Subject: Revised Operations, Monitoring, and Maintenance Plan  
Vapor Mitigation System and Cap  
Buildings 127A, 127B, and 128A  
Section BR11-1 - Fuel Distribution System  
Riley Avenue, Presidio of San Francisco, San Francisco, California

**Revised Operations, Monitoring, and Maintenance Plan  
Vapor Mitigation System and Cap  
Buildings 127A, 127B, and 128A**

Section BR11-1 – Fuel Distribution System  
Riley Avenue  
Presidio of San Francisco, San Francisco, California

Subject: **Water Board Review of the November 2, 2019 Operations, Monitoring, and Maintenance Plan, Building 127B Vapor Mitigation System and Buildings 127A and 127B Cap  
Riley Avenue Site  
Fuel Distribution System Section BR11-1  
Presidio of San Francisco, San Francisco, California**

<b>PROJECT:</b>	
THE PRESIDIO TRUST BR11-1 FUEL DISTRIBUTION SYSTEM RILEY AVENUE, SAN FRANCISCO, CALIFORNIA	
<b>TITLE:</b>	
EXISTING CAPPING	
DRAWN BY: KQ	PROJ NO.: 285830.00001A.TASK07
CHECKED BY: L. SHANNON	<b>FIGURE 4</b>
APPROVED BY: L. SHANNON	
DATE: DECEMBER 2019

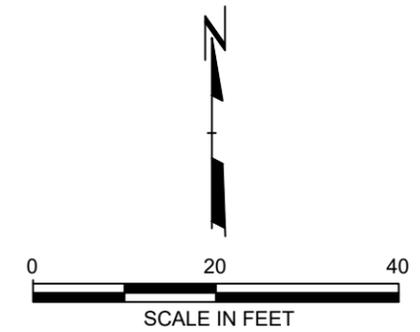
**Comment 3:** Revise the OMMP to describe in the text and delineate on a map a LUC area for the basement slab at Unit 128A. Additionally, revise the OMMP to describe the LUCs to be implemented including, but not limited to: annual slab inspection, inter-occupancy air sampling, trend analysis of indoor air data to determine whether or not soil VI to indoor air is occurring, and timely completion of responses to mitigate any potential exposure prior to re-occupancy.

addendum to the Presidio Trust Land Use Controls Master Reference Report, which is pending preparation. The extents of the LUC for Buildings 127A, 127B, and 128A are shown in **Figure 4**.

The existing basement concrete floor slabs at Buildings 127A and 128A provide mitigation of potential soil vapor intrusion and are the vapor intrusion mitigation for the buildings. Indoor air investigations conducted to date indicate that under current conditions there is no unacceptable risk to human health from soil vapor intrusion (RWQCB, 2018a and 2019c). Inspection and maintenance of existing concrete are included in this OMMP. The extent of the concrete basement slabs is presented in **Figure 4**.
